**NEXTERA ENERGY POINT BEACH, LLC
POINT BEACH NUCLEAR PLANT, UNITS 1 AND 2**

**LICENSE AMENDMENT REQUEST 261
EXTENDED POWER UPRATE**

NON-PROPRIETARY RESPONSE TO REQUEST FOR ADDITIONAL INFORMATION

December, 2009

Figure 9a: Cladding Temperature at PCT Elevation (10.75 ft)

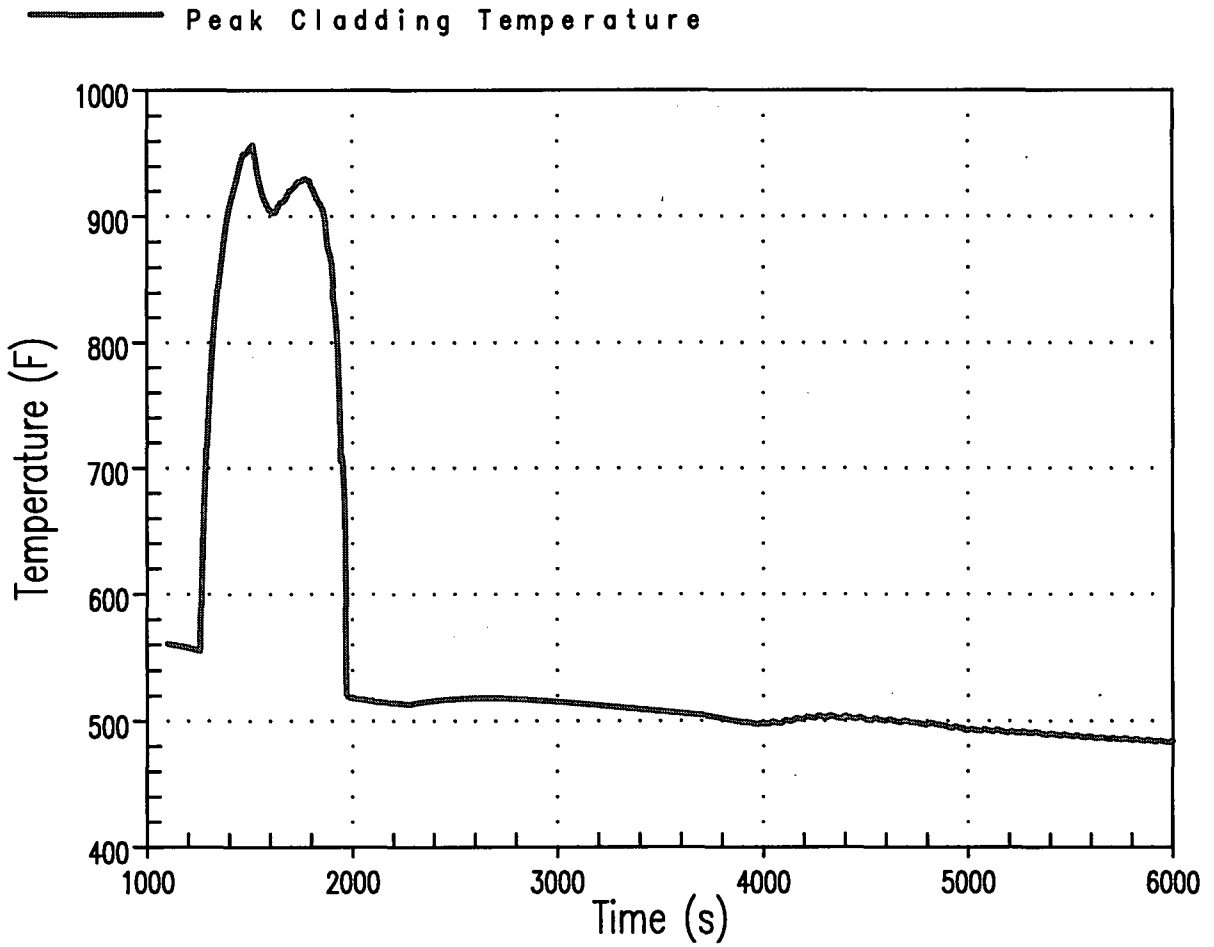
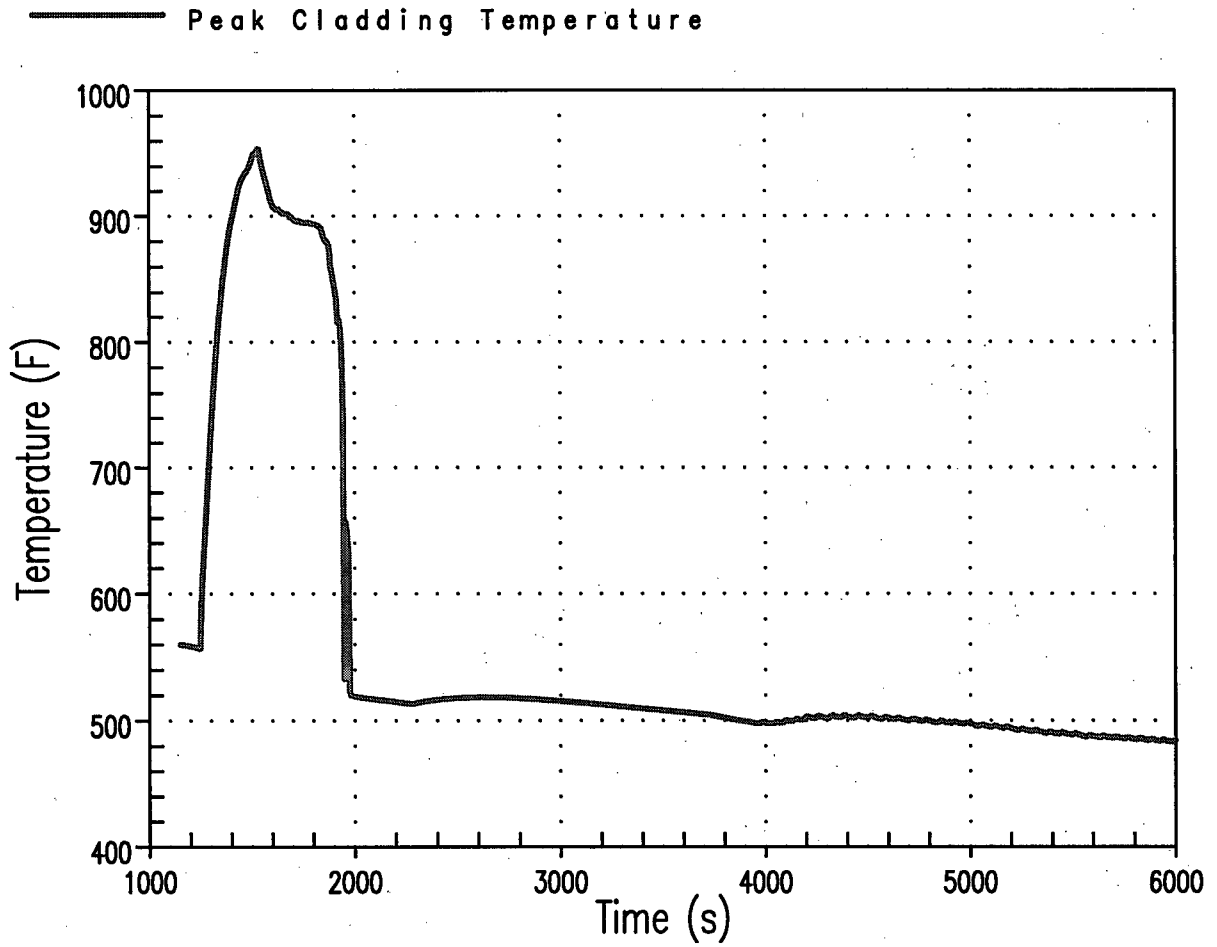
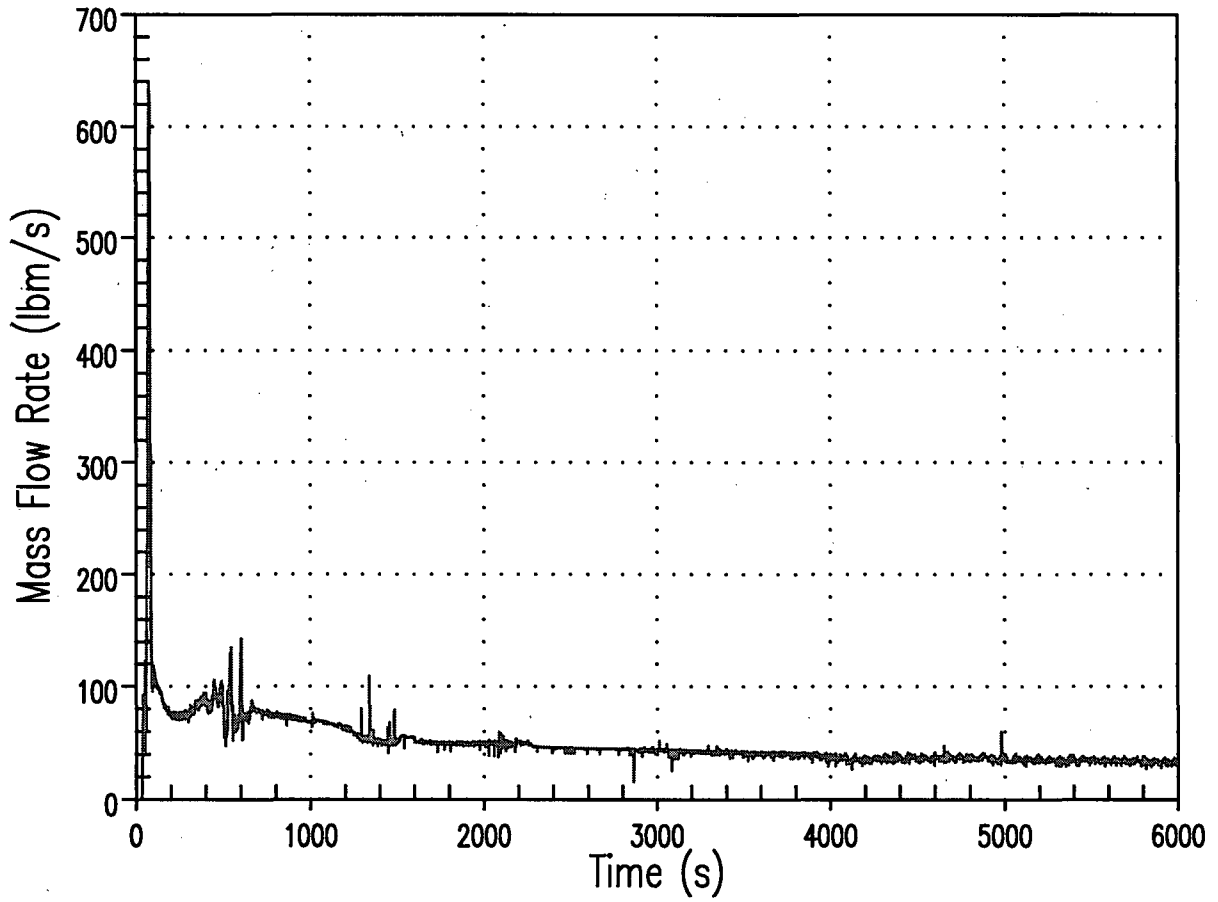
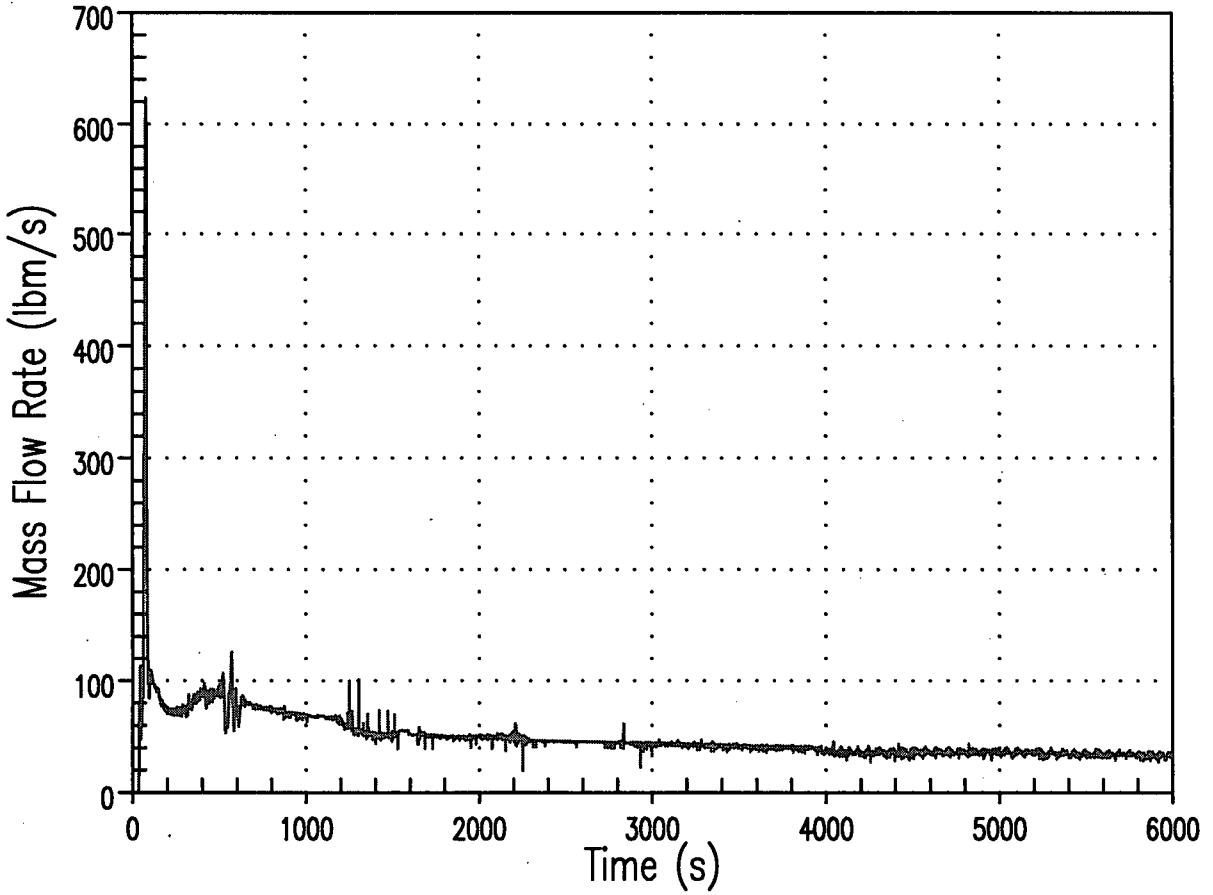
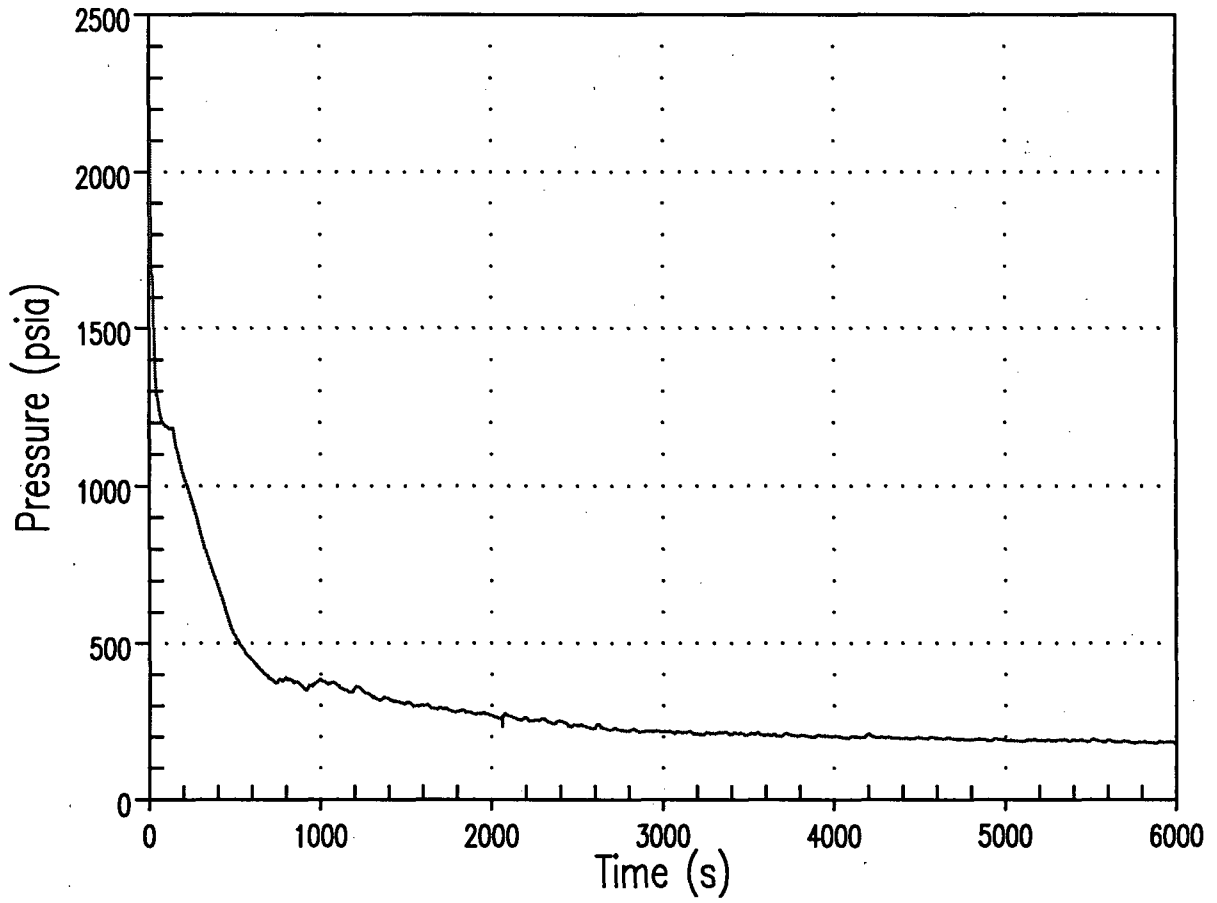
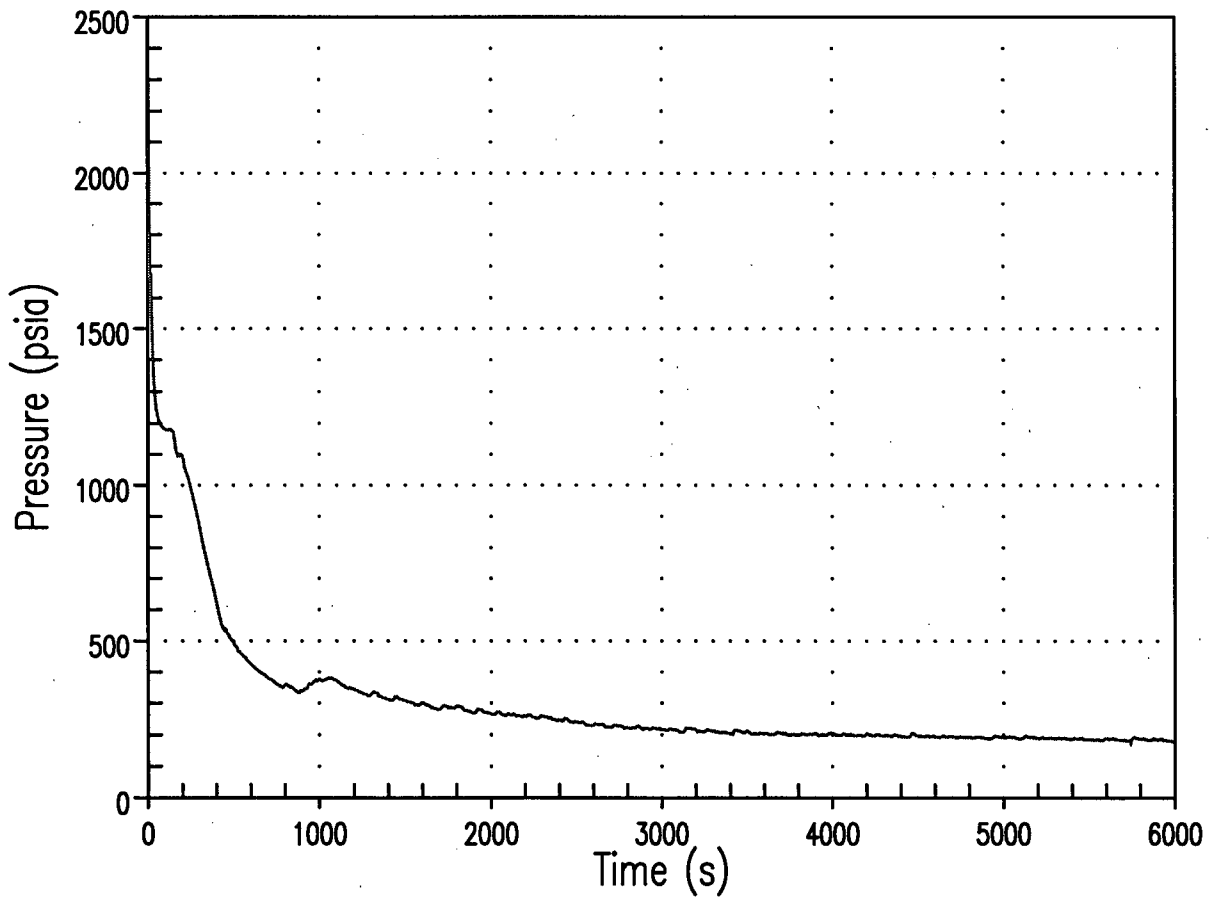
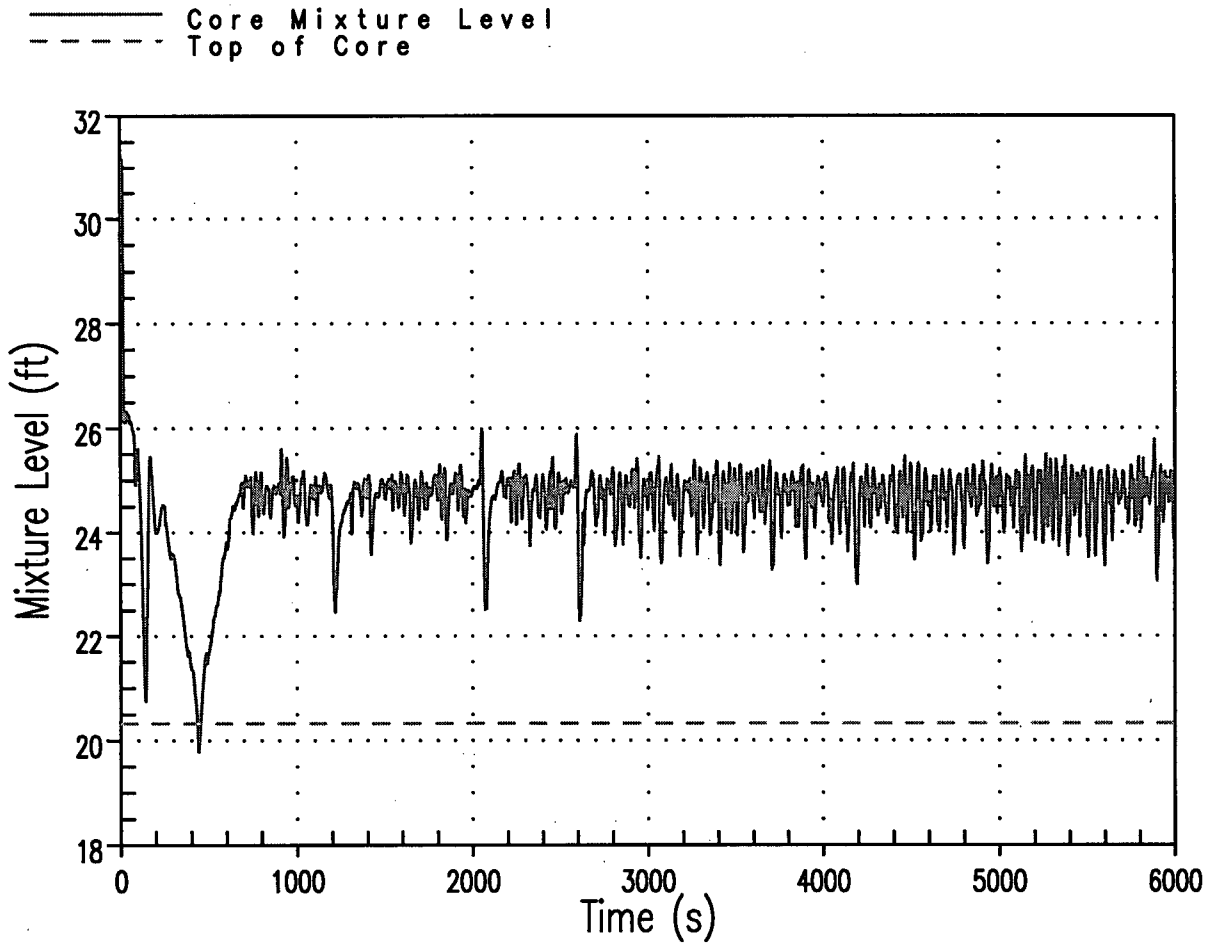
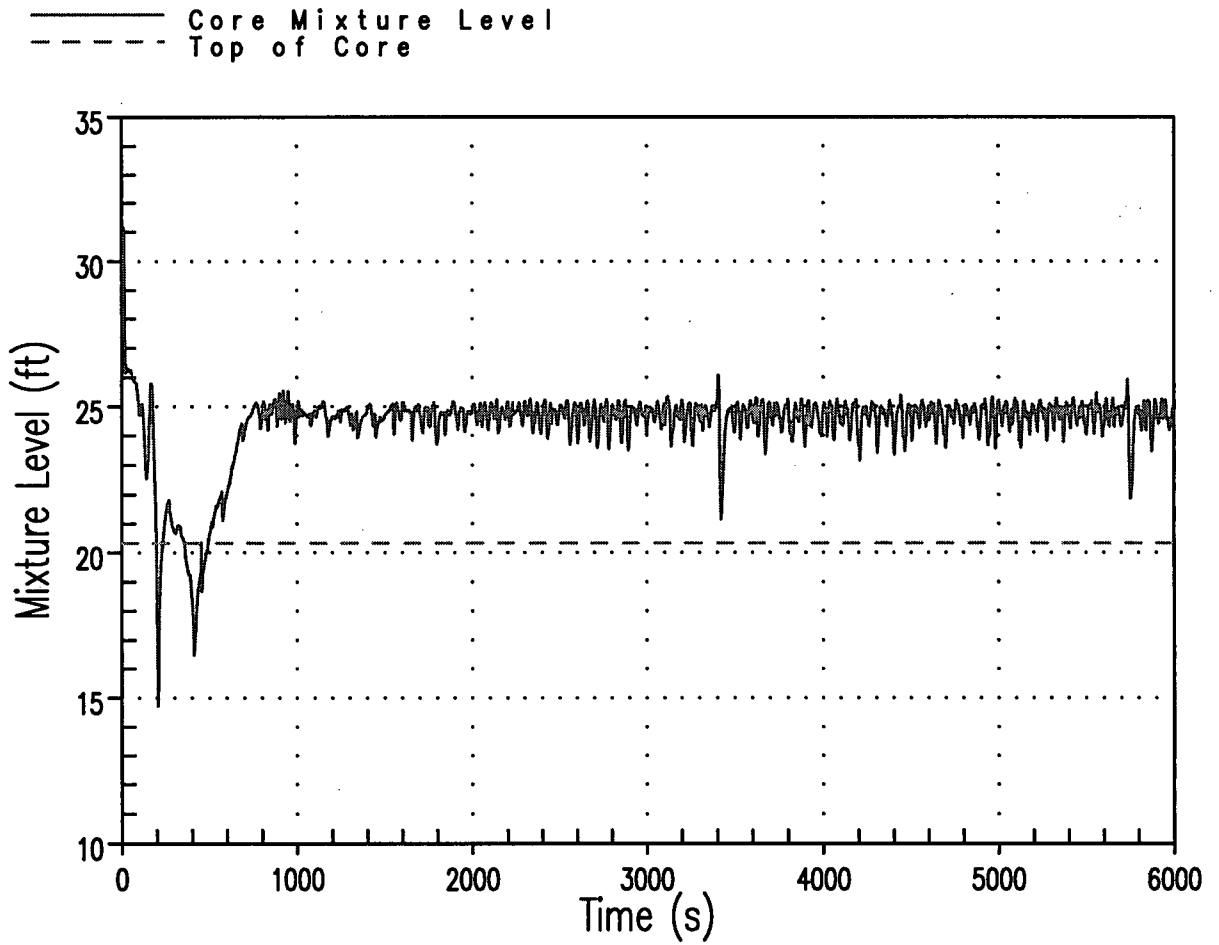
- 1) Page 2.8.5.6.3-6 of the Point Beach Extended Power Uprate (EPU) Licensing Report (Enclosure 5 to Reference 1) indicates that the small-break loss-of-coolant accident analysis was performed using the NOTRUMP evaluation model. Please provide a copy of the NOTRUMP analysis report that supports the EPU application.**

The NRC reviewer provided clarification of this RAI during a teleconference held between Westinghouse, FP&L, and the NRC. It was concluded that the transient response results of the non-limiting breaks, which are not provided in the LAR, will be provided. Transient response results for the limiting 3-inch break for both Point Beach Units 1 and 2 are provided in the small break LOCA LAR Section 2.8.5.6.3. The same response results for the non-limiting breaks are provided below. The following comments apply:

- Peak cladding temperature transients are not provided for the 6- and 8.75-inch breaks as these breaks experienced little to no core uncover.
- Low head safety injection flow figures are provided only for the 6- and 8.75-inch breaks. LHSI was only modeled for the 6- and 8.75-inch breaks (during RWST injection phase only). Breaks less than 6-inches in equivalent diameter did not reach the LHSI cut-in pressure.
